**From:** Ethan Ahlberg  
Noll & Tam Architects

**Re: 08ESMF00-2012-TA-0387-1  
Corps File No. 2012-00032S - Oakland Zoo California Trail  
Further details and clarifications – Section 7 Consultation  
Response to Fish and Wildlife Service Letter Received May 1<sup>st</sup>, 2012**

**Re: Oakland Zoo California Trail  
Fire Fuel Management Plan Framework**

**SITE PLAN - FIRE FUEL MANAGEMENT DIAGRAM**  
 1/16" = 1'-0"

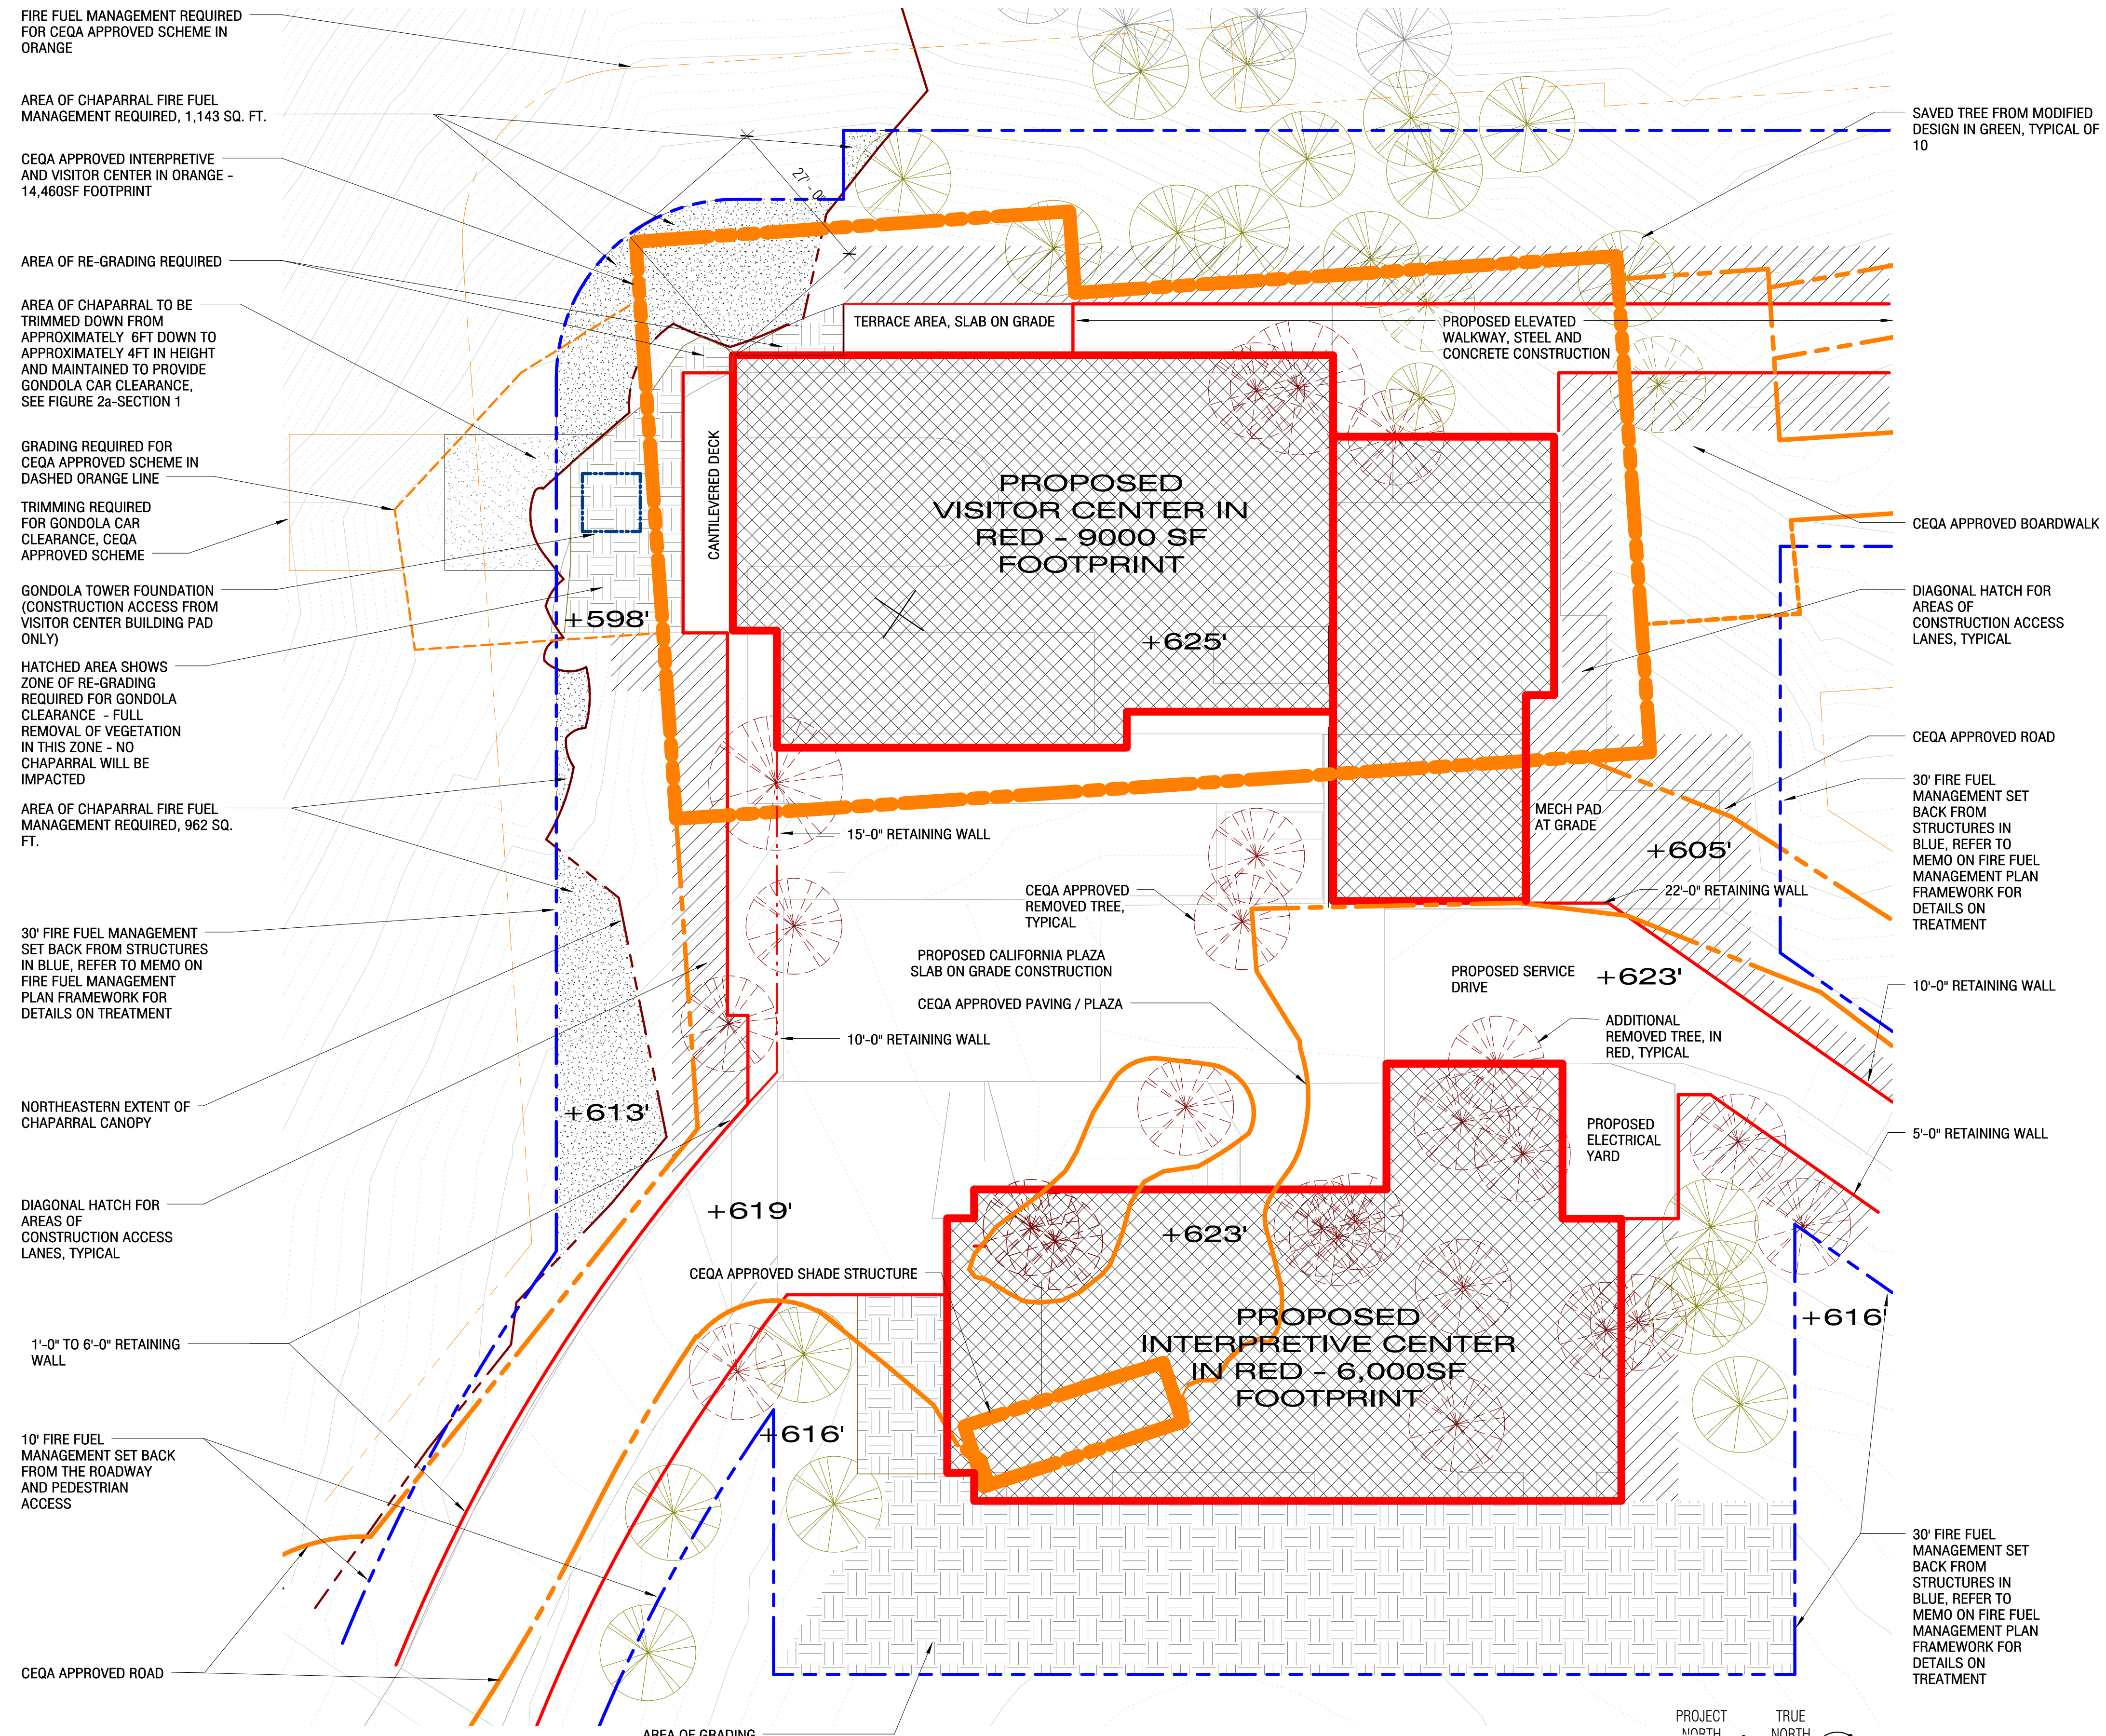
- 28) Page 33, Section 5.1.3 Impacts Due to Fuel Management: Please provide a fuels management plan for this project. This section is too vague to fully analyze potential effects to individuals and habitat. On-going maintenance is considered a permanent effect to habitat. Will fuel management need to occur in other areas like the perimeter fence? Also, "take" as mentioned in the last sentence of this section is appears to be referring to the State definition of "take". The federal definition of take includes harm in the form of habitat loss and not just effects to individuals. This is an important distinction.

Refer to **SK-Arch-001** for the Visitor Center and Interpretive Center footprints. The original Interpretive Center design approved by the City of Oakland in a thick orange line. Subsequent to this approval process, the canopy line of the Chemise chaparral which constitutes the core habitat for Alameda whipsnake has been surveyed and the project has been refined in response to this information. This has been addressed by relocating a large segment of the building program to a 2<sup>nd</sup> building located further to the interior of the California Trail project, away from the chaparral habitat, and taking the place of the previously designed Grizzly Bear Viewing structure and plaza area. This building is called the Interpretive Center, and the building located near the original position is called the Visitor Center. The Visitor Center is a 3 story structure that sits in the hillside with the 1<sup>st</sup> floor matching grade on the northwest side, and the 3<sup>rd</sup> floor at grade on the southeast side. The Interpretive Center is a single story structure, located at roughly the same elevation as the 3<sup>rd</sup> floor of the Visitor Center, sharing a plaza space and fire access lane between them. The footprints of these two buildings are shown in red. This design modification allowed the Visitor Center footprint to be moved 27ft to the east out of and away from the chaparral habitat. An exterior deck constructed of concrete will cantilever 12 feet beyond the building footprint on the west facade by 12ft. This will not affect the extent of the fire fuel management, as verified during consultation with the Oakland Fire Marshal on November 6, 2012 (see response to Question 28 below).

Vegetation Management within the fire fuel management zone will affect limited areas of chaparral cover, as indicated in **SK-Arch-001**. The edge of chaparral canopy was mapped by engineer survey, and is depicted in the figure by the dashed brown line, with areas of affected chaparral cover shown in hatching. An additional zone of chaparral will require routine pruning beyond this fire fuel management zone to provide gondola access into the building, which is also depicted in SK-ARCH-001 and reflected in cross-section 1 in **Figure 2a**.
